**ALAMEDA COUNTY COMMUNITY DEVELOPMENT AGENCY
PLANNING DEPARTMENT**

STAFF REPORT

APPLICATION: PLN2018-00086

PROPOSAL: **TRACT MAP SUBDIVISION (TR-8488) AND SITE DEVELOPMENT REVIEW**, New mixed-use multi-family project with 163 rental housing units, 11,524 sq. ft. of indoor retail, 660 sq. ft. of outdoor retail seating area

BLDG. 1 (TYPE A) - EXITING DIAGRAM 1

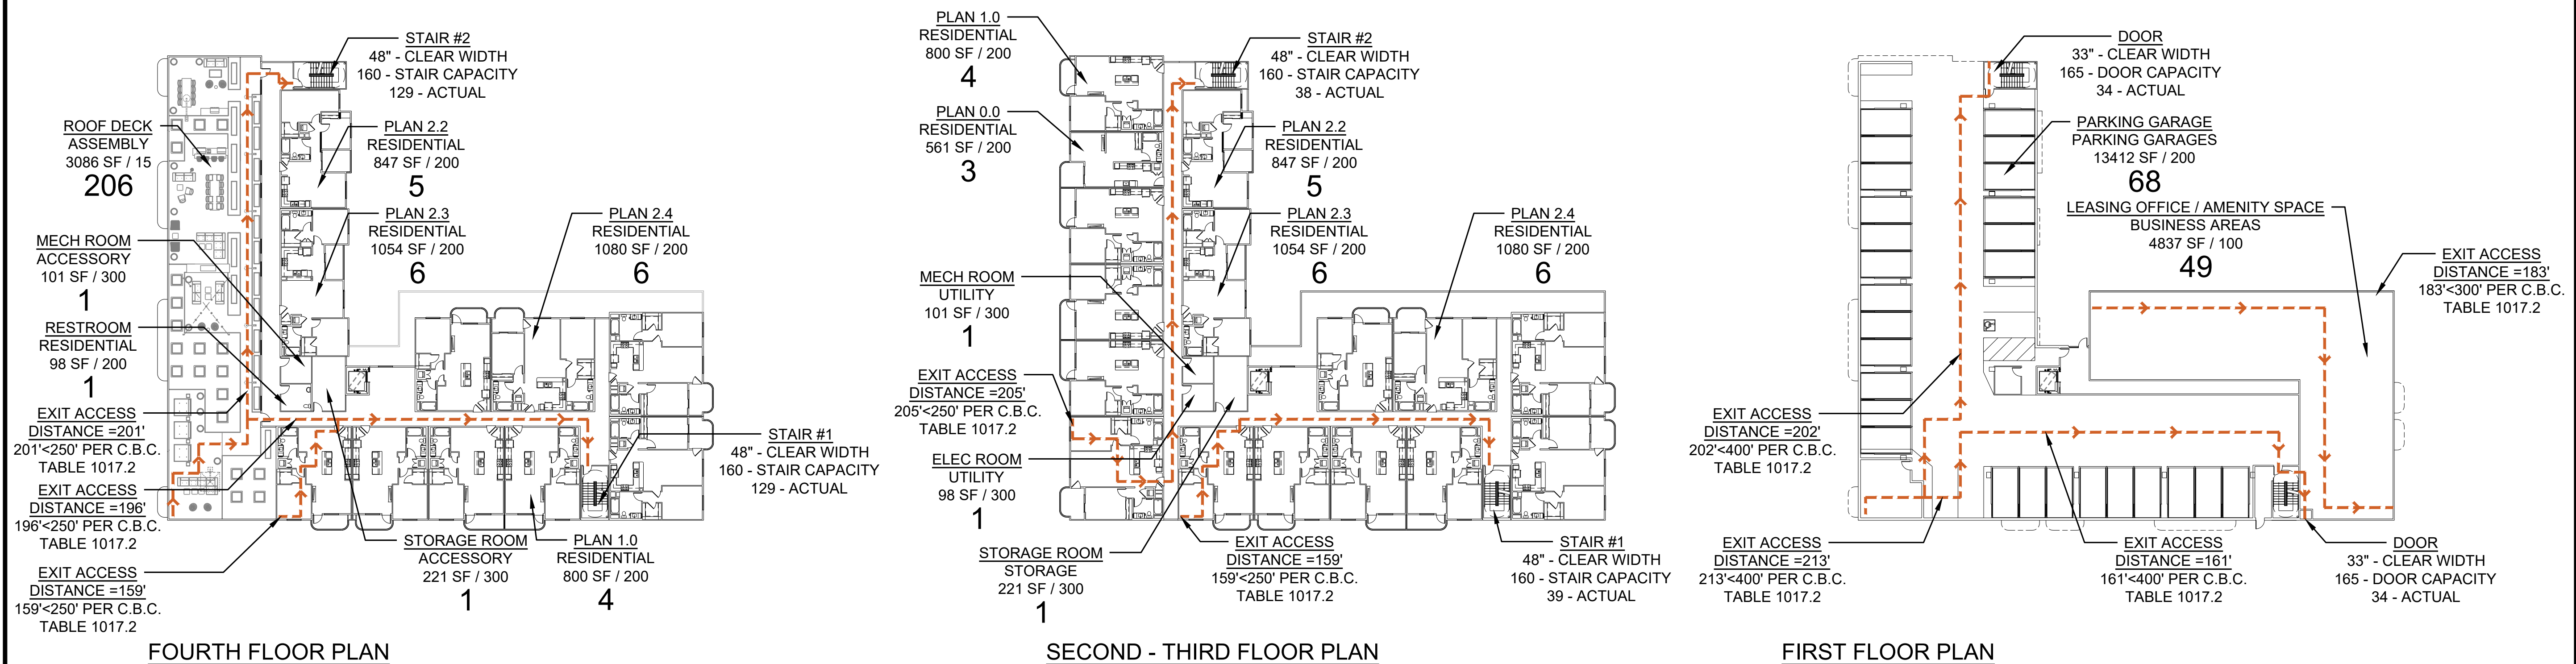
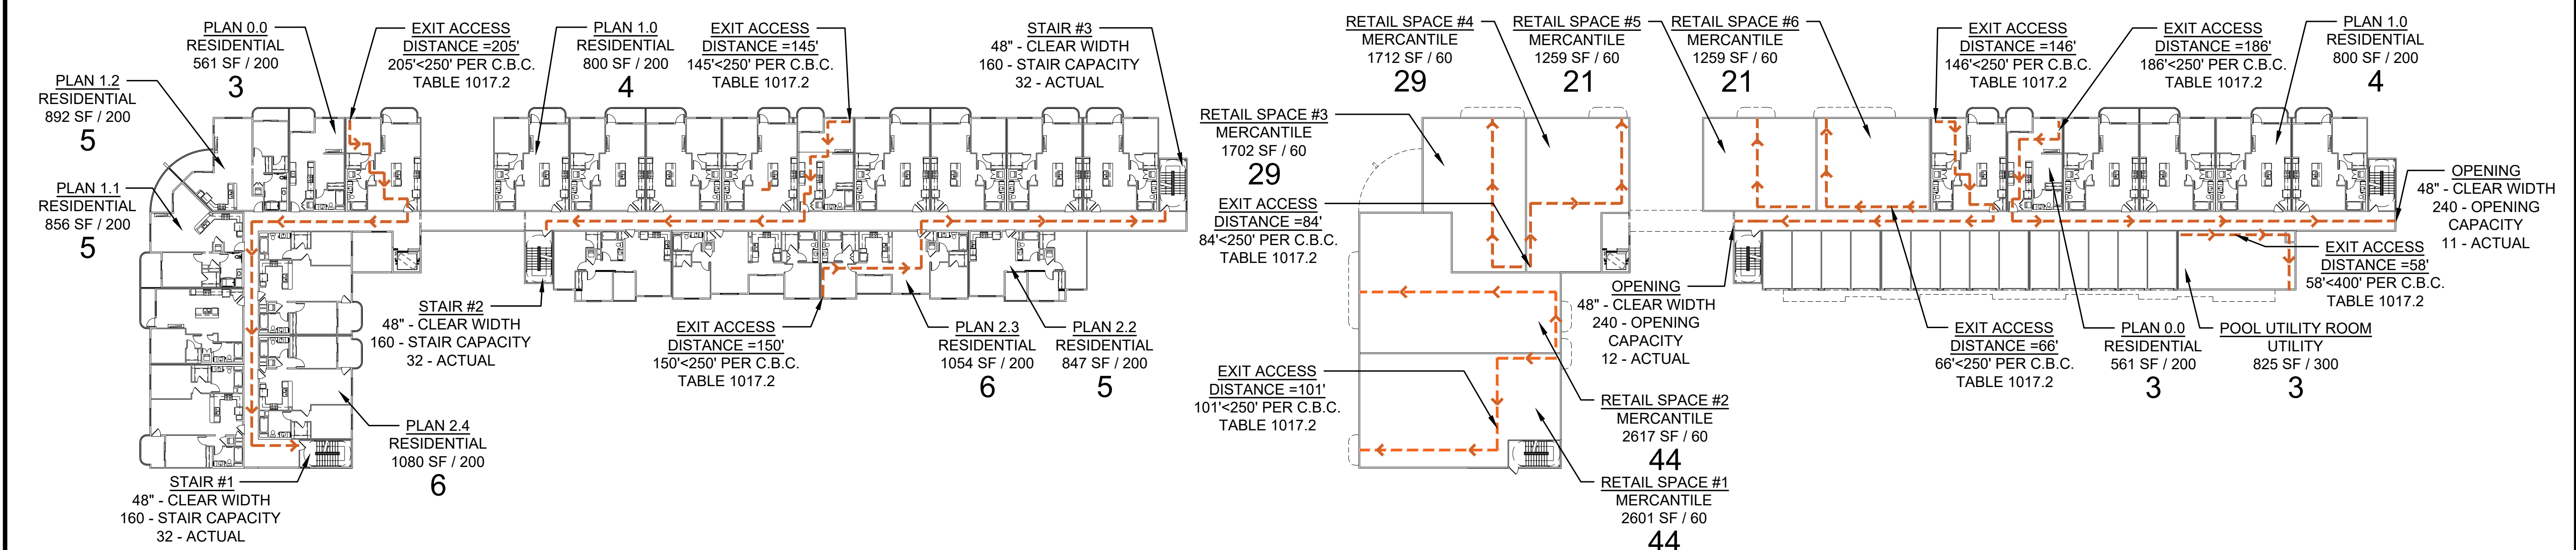
4. *9/6/18- On the plans provide the occupancy classification(s) of each building.*
 - ❖ *The occupancy classification per building has been added to the general information sheet as well as the exiting diagram sheet, refer to sheets G0.0 and G0.2.*

C4.0 UTILITY PLAN

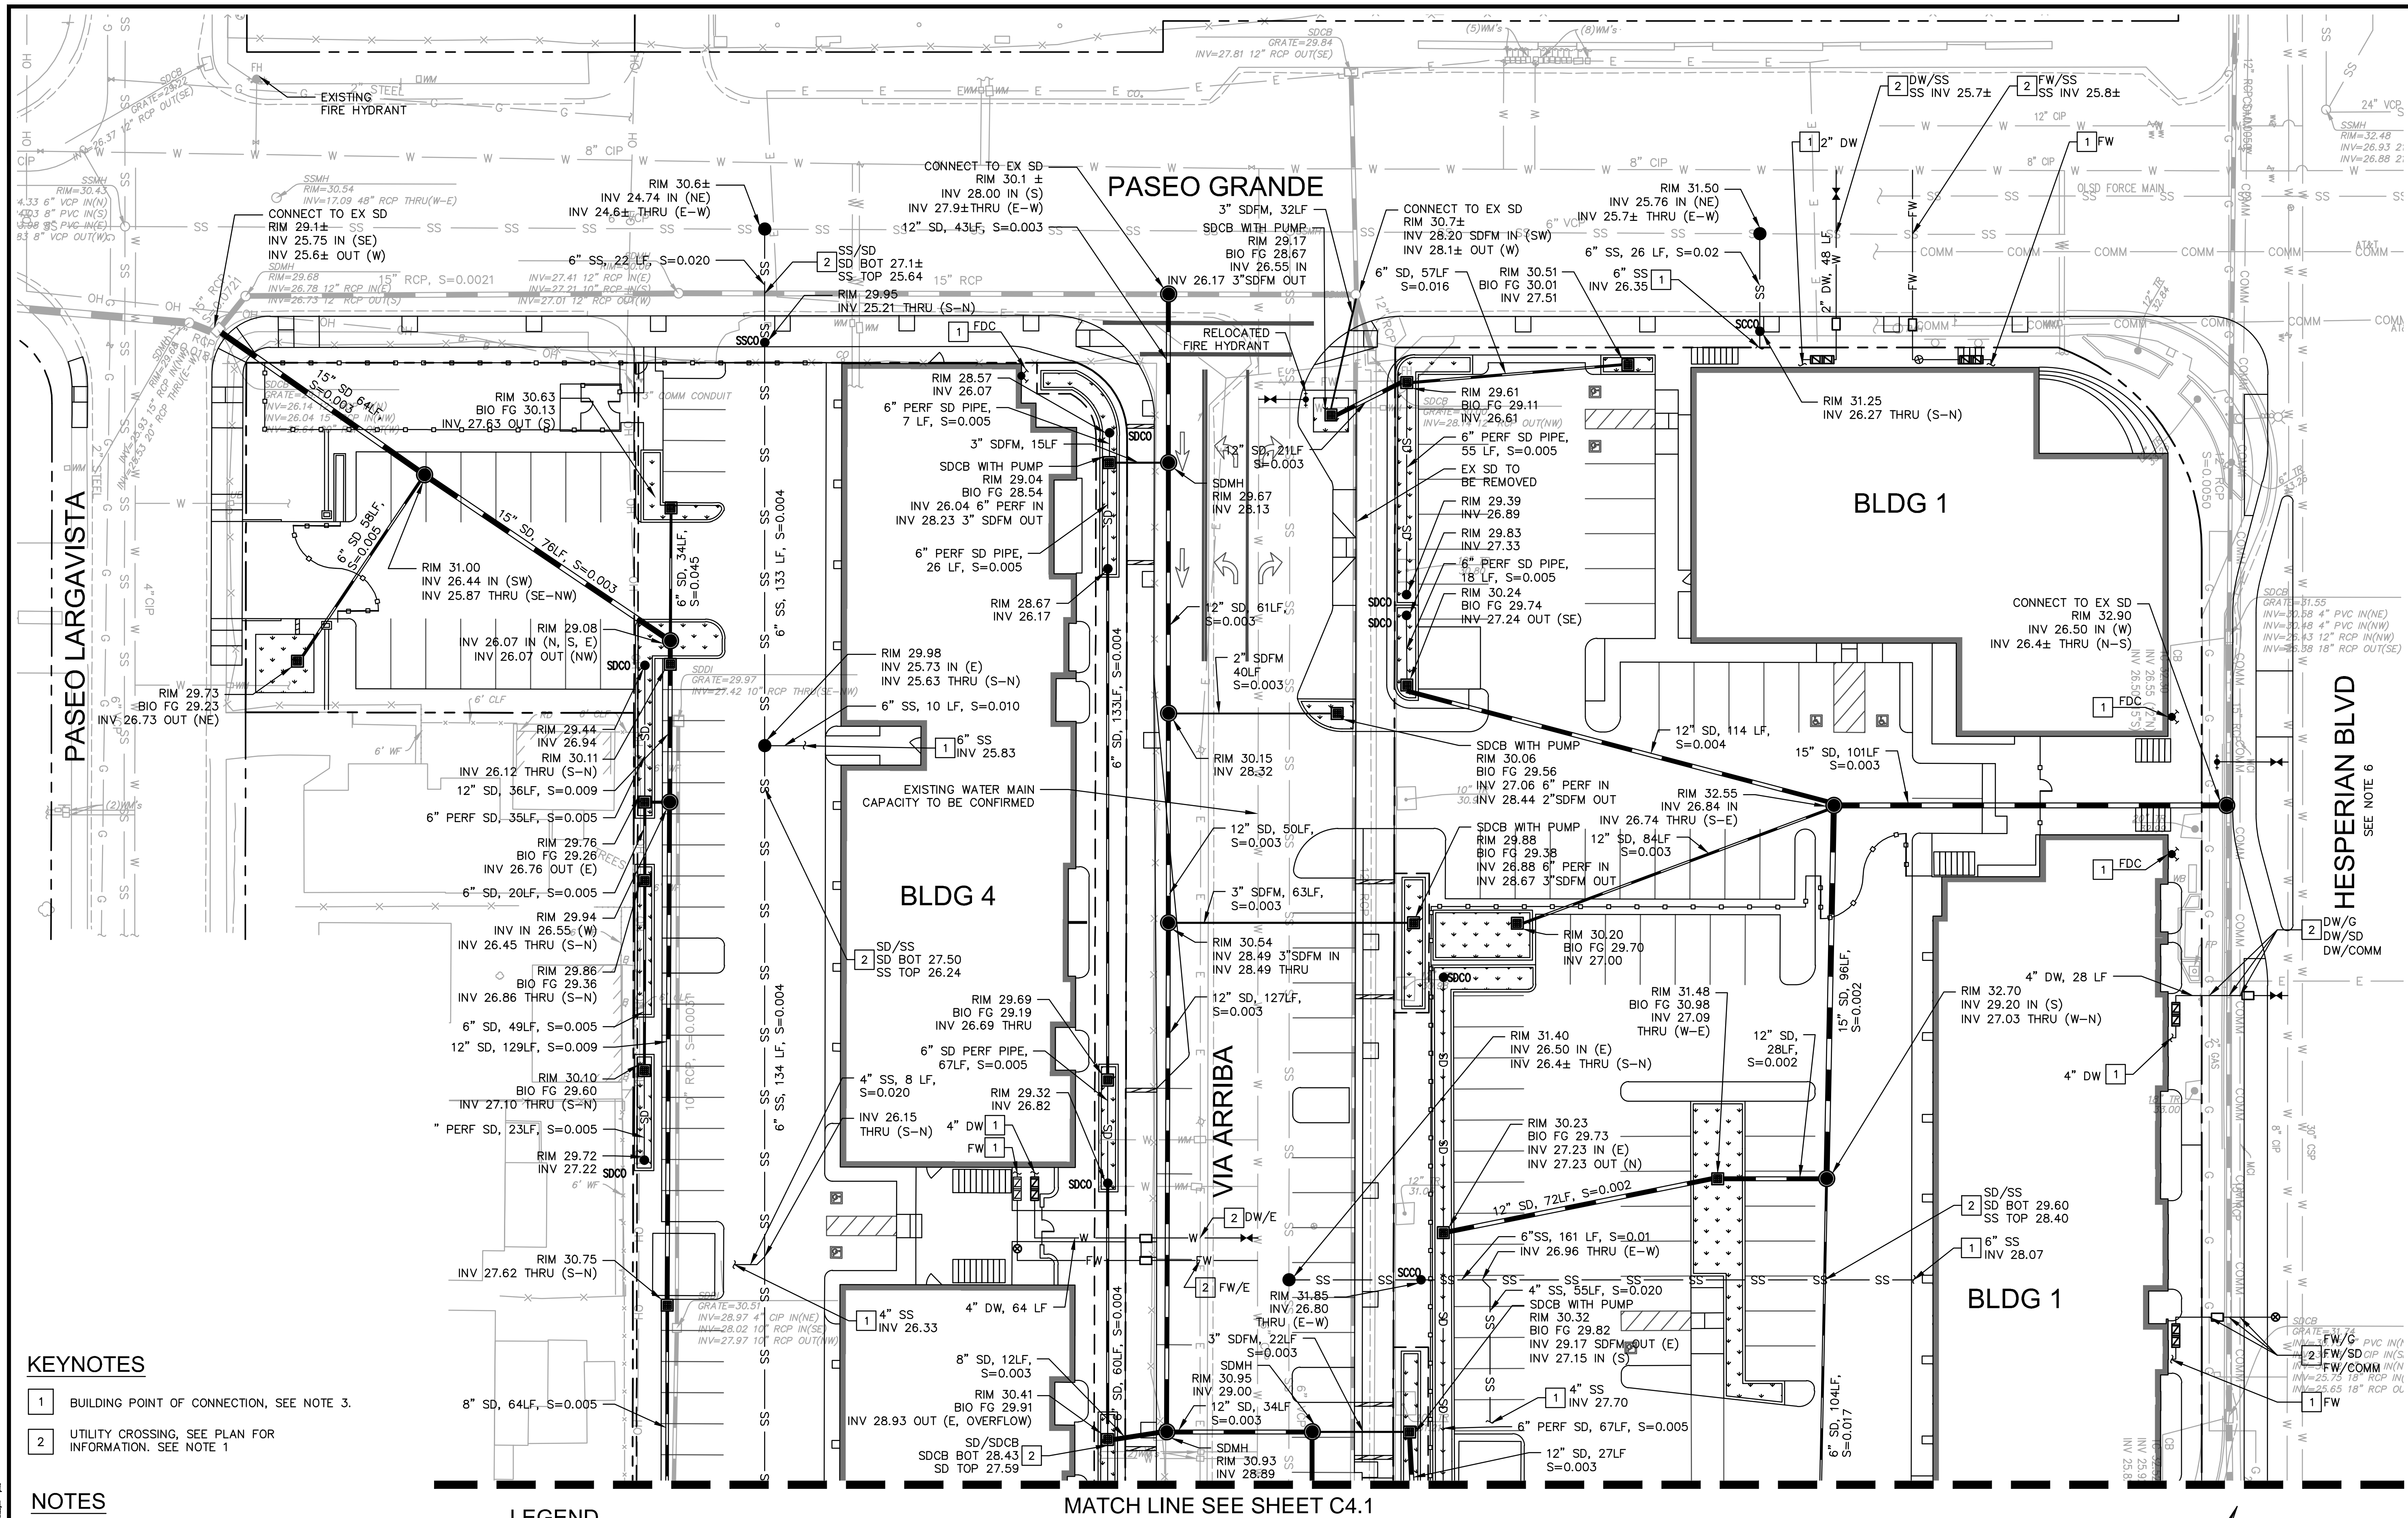
12/7/18- Note sprinkler piping cannot be run under the building unless it meets the requirements of NFPA 24. On sheet C5.0 please clarify if building 1 has two fire sprinkler risers as there are two connections shown.

3. **12/7/18- On sheet C5.0 the fire hydrant shown between buildings 3 and 3 does not appear to be connected to the water supply. Please clarify.**

4. **12/7/18- On sheet C5.0 there is a fire hydrant shown stating Relocate existing fire hydrant. It is not clear where it is relocated to or from.**

C4.1 UTILITY PLAN

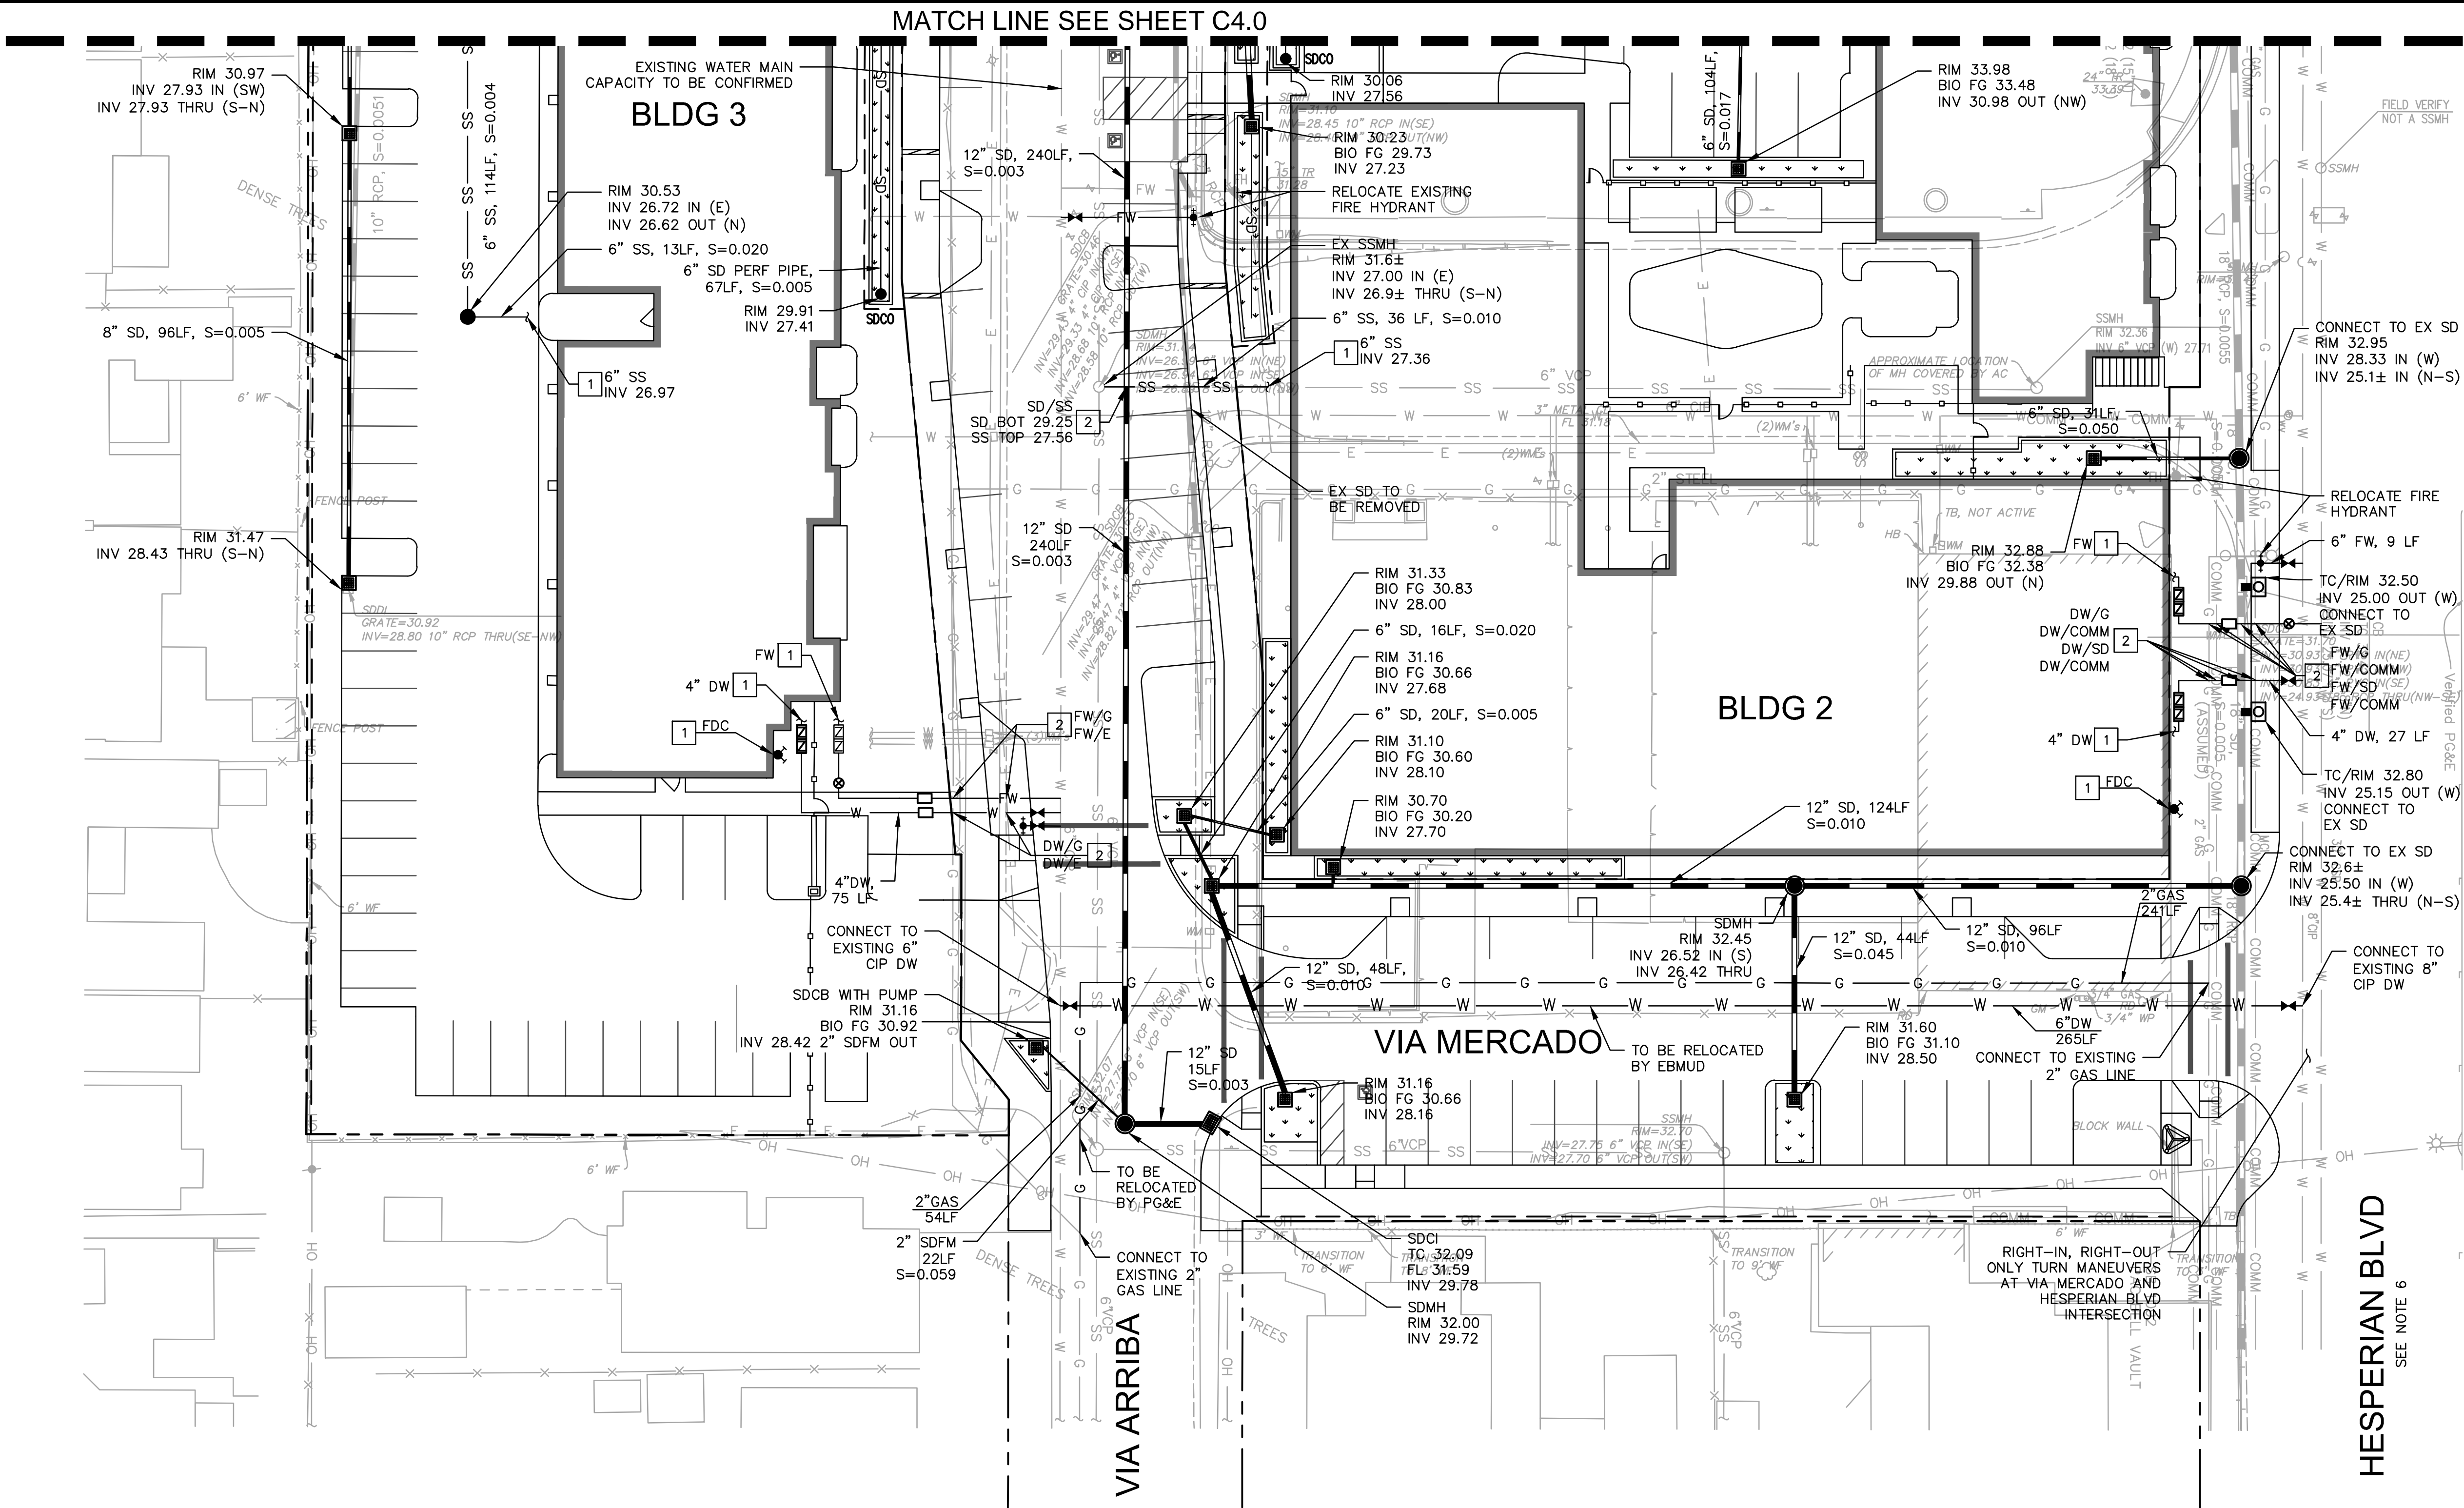
- Per the note on Sh. C4.1, the non-LID media filter units have not been sized. These facilities consist of underground vaults or manholes with interior racks that mount a series of treatment filters; the plans show most of the filter units under sidewalk areas, but most of the standard vault types are 6' -- 8' wide so it could be a tight fit. The manholes are obviously smaller, but with much less capacity.
